MAIN FLOOR PLAN! (with new electrical)

Tosti-Lane Home Remodel Project

Plan Review #B94042

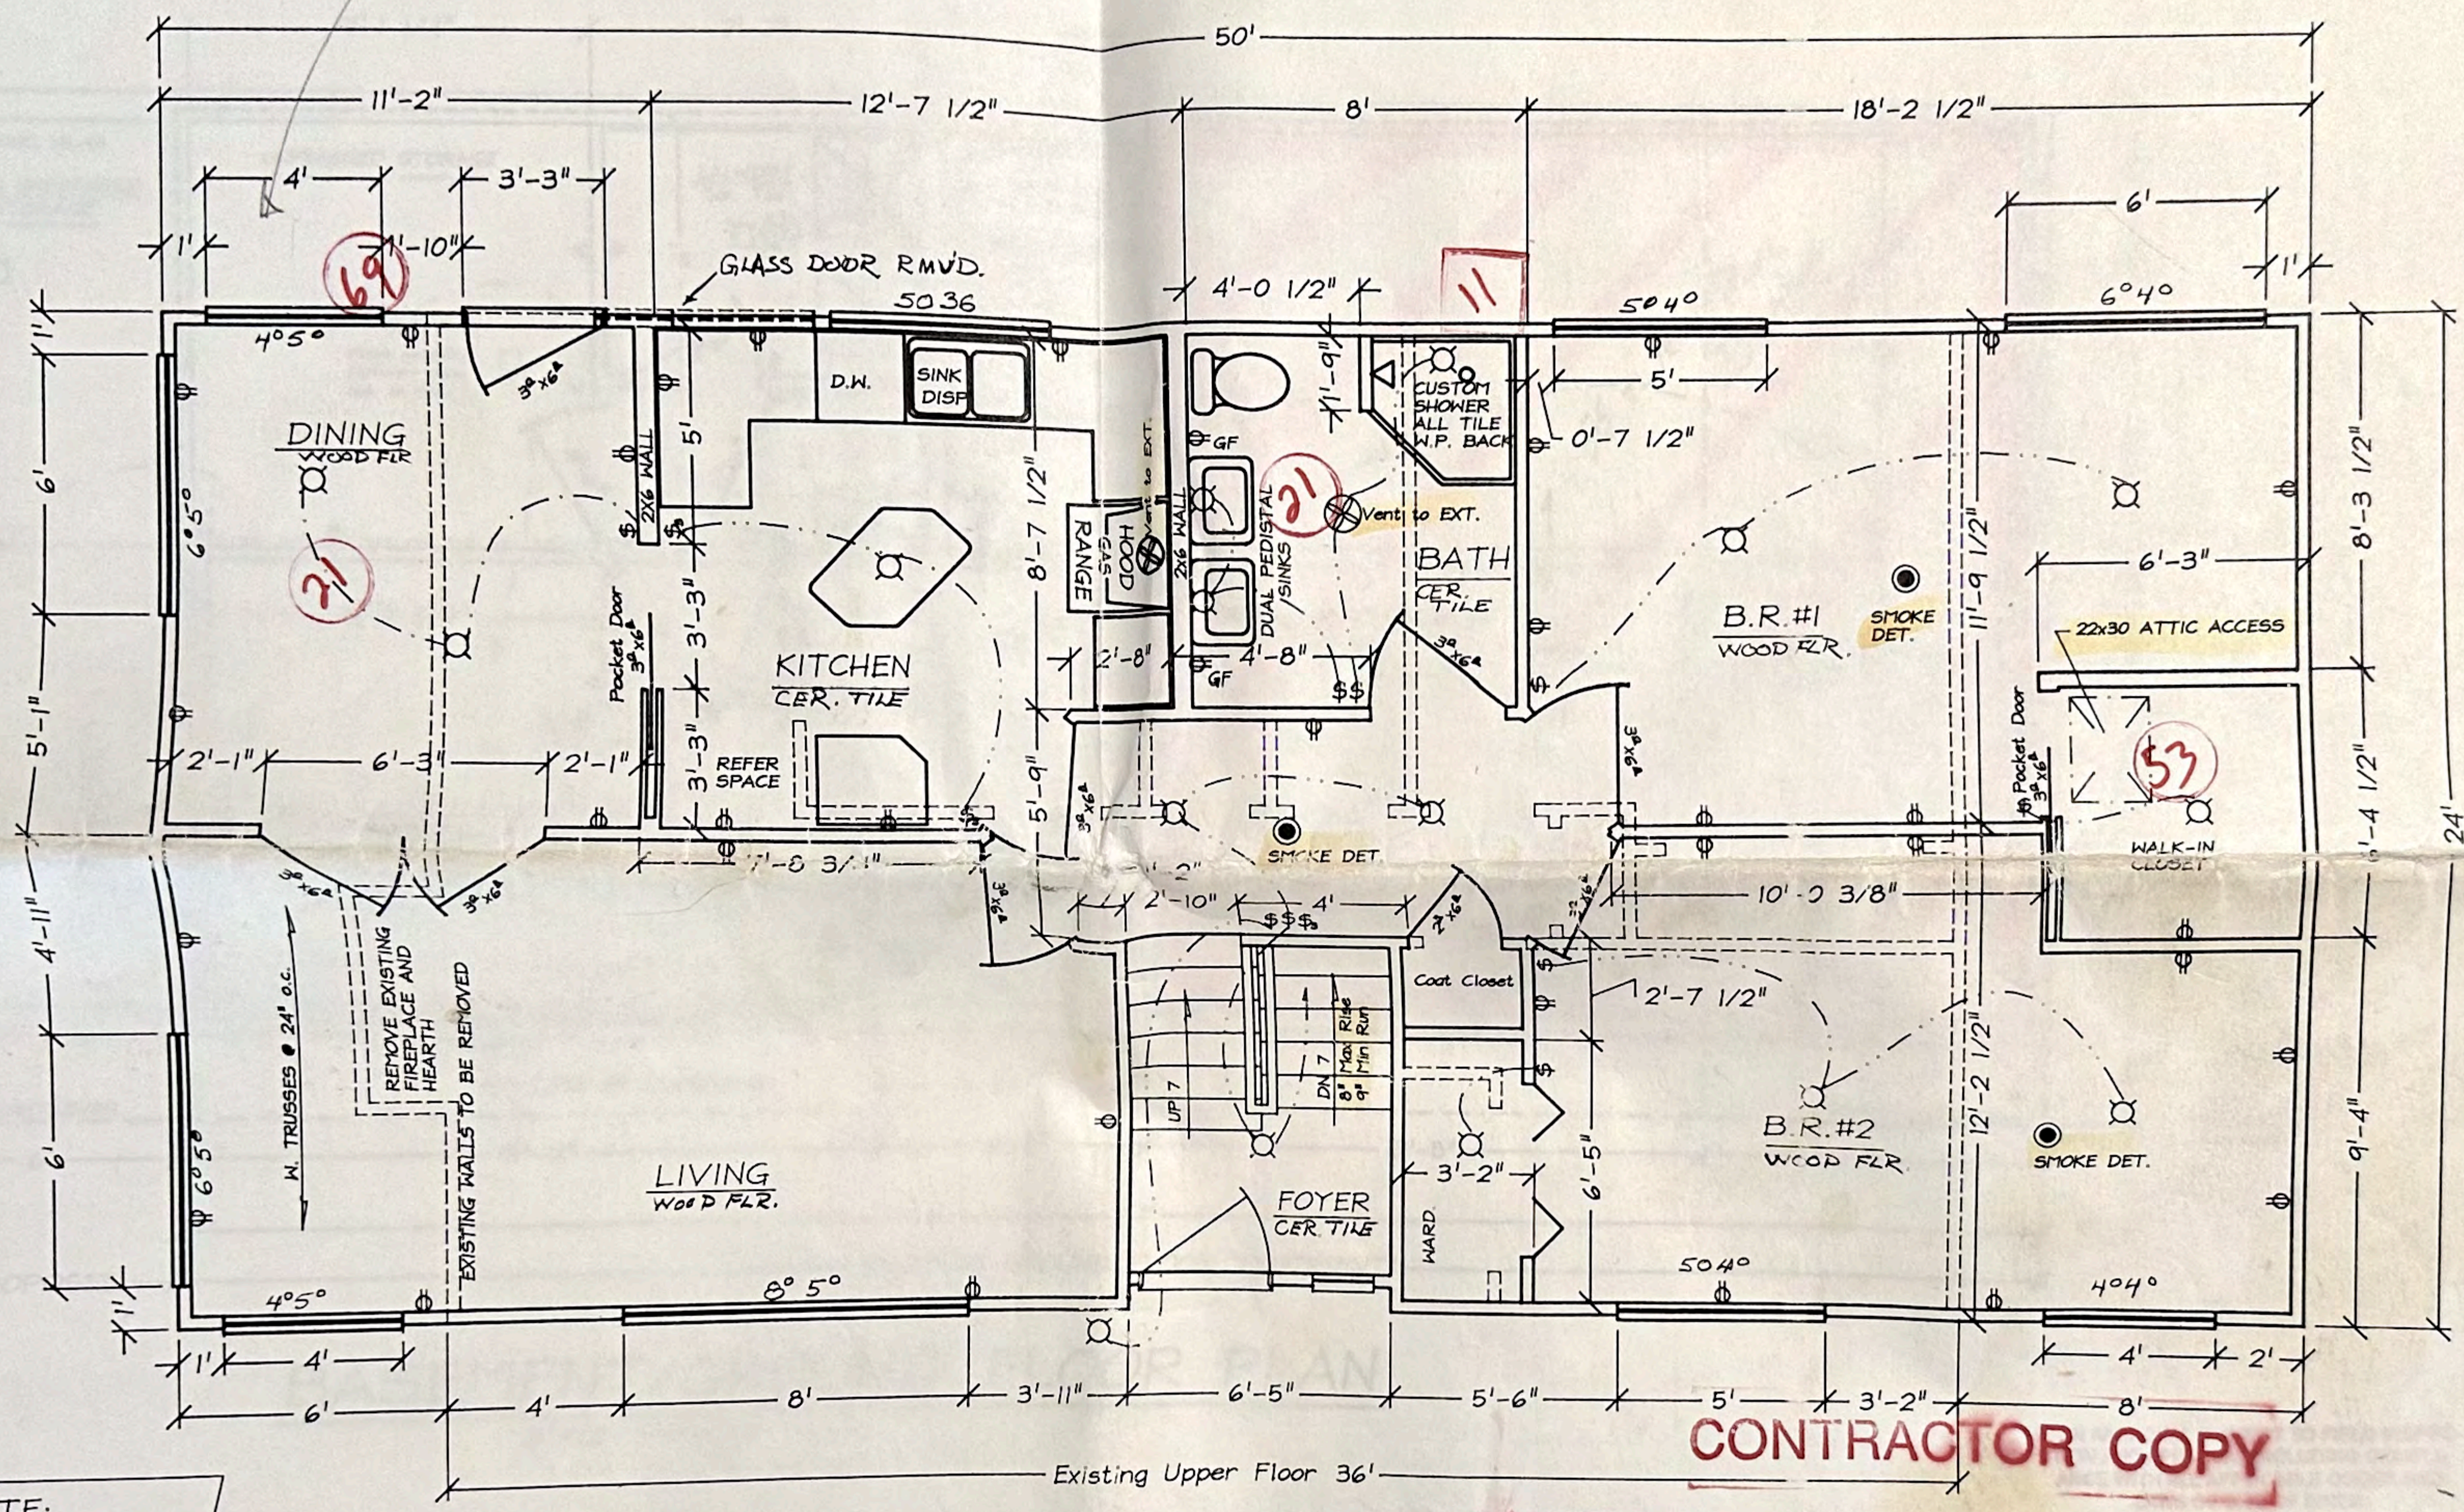
Move window
to Achieve 24
on 5/06 (D)(3)

#12 Wire Minimum.
GFCI Recept. Front & Back

Air Chambers Required At All Sinks & Washer
